Re: License Amendment  
License No. 06-19549-01

Project NUCLEAR GAUGE STORAGE LOCATION

STORAGE LOCATION: 87 WASHINGTON AVE BRIDGEPORT, CT.

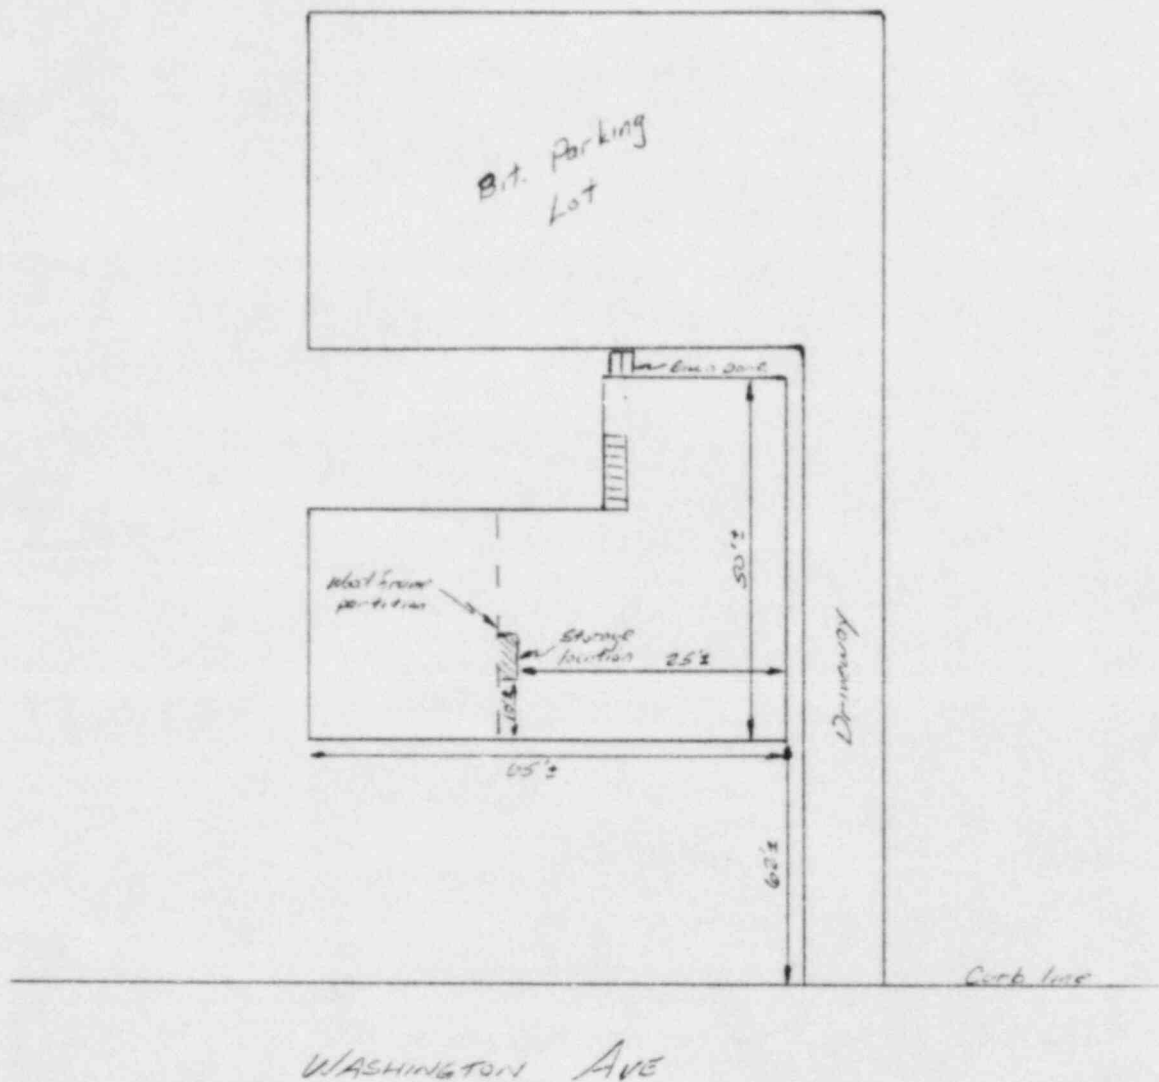
Item 13b - Storage Facilities - Change to indicate

Location 1 - 87 Washington Avenue, Bridgeport, CT. 06604  
Location 2 - 9 Moscariello Place, Norwalk, CT. 06853  
Sketches of locations are enclosed

STORAGE LOCATION IS IN BASEMENT OF 87 WASHINGTON AVENUE. GAUGE TO BE SECURED IN WOOD STORAGE CABINET AND CHAINED TO STEEL SUPPORTING COLUMN.

BUILDING IS PROTECTED BY INTRUSION ALARM AFTER WORKING HOURS.
